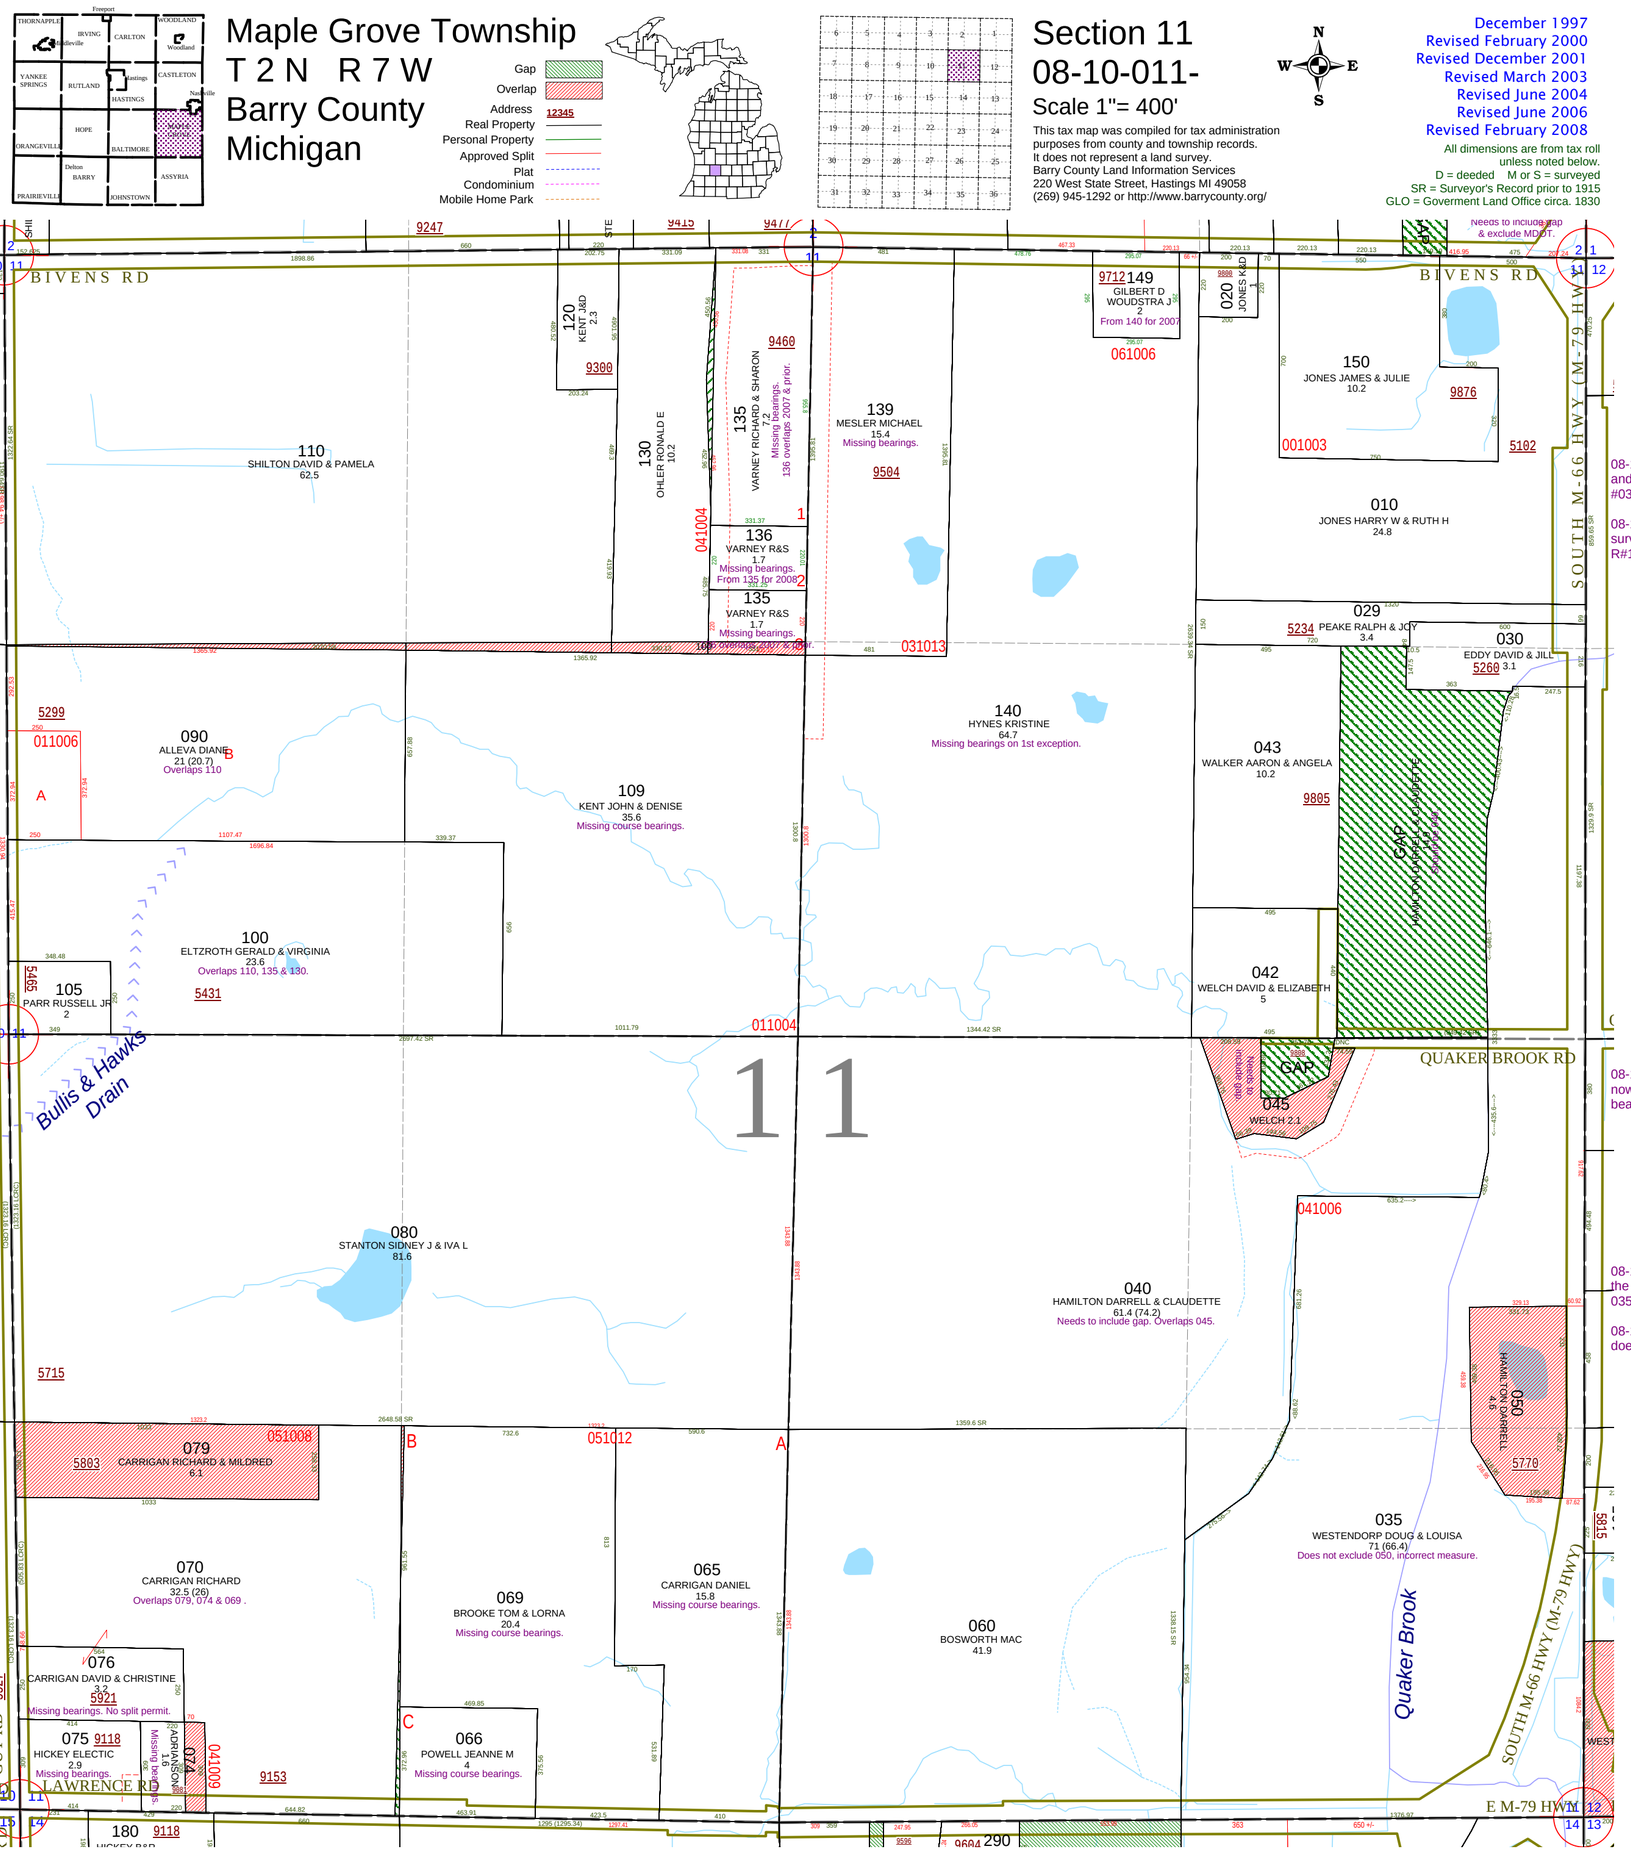
08-10-011-135-00 needs to include gap parcel to the west and should read as resurveyed for property line adjustment and quit-claims among Shilton, Varney, Kent & Hawkins. See parcel 1 & 3 of split #041004

08-10-011-136-00 is missing its course bearings and dimensions are rounded off. See parcel 2 of split #041004

08-10-011-090-00 overlaps 110 and needs to be described as surveyed for parcels A&B of split #011006.

08-10-011-100-00 overlaps 110, 130 & 135 and should be described as remainder of splits #011004 & #011006.

08-10-011-109-00 is missing its course bearings and should be described as surveyed for split #011004.

08-10-011-139-00 is missing its course bearings and needs to be described as surveyed for split #031003.

08-10-011-140-00 needs to exclude 139 as surveyed with course bearings and new split in R#1163554.

08-10-011-045-00 is missing original parcel entirely now, incorrect point of beginning and errors in bearing. See deed R#1149193.

08-10-011-040-00 needs to include gap parcel to the north that was with this parcel prior to split to 035.

08-10-011-035-00 has an incorrect measure and does not exclude 050. See deed R#1106595.

08-10-011-079-00 is missing its course bearings as surveyed for split #051008.

08-10-011-065-00 has a kink on the west line and needs to be described as deeded in R#1137387 with course bearings.

08-10-011-069-00 overlaps 070 as described because it is missing its course bearings and needs to be described as surveyed for parcel B of split #051012.

08-10-011-070-00 overlaps 069, 074 & 079 and those exceptions have been surveyed for splits #011005, #041009 & #051008

08-10-011-076-00 is missing its course bearings and has been surveyed for split #011005

08-10-011-075-00 is missing bearings has been surveyed for split #011005.

08-10-011-074-00 is missing its course bearings and needs to be described as surveyed for split #041009.

08-10-011-066-00 needs to be described as deeded in R#1135161 with course bearings.
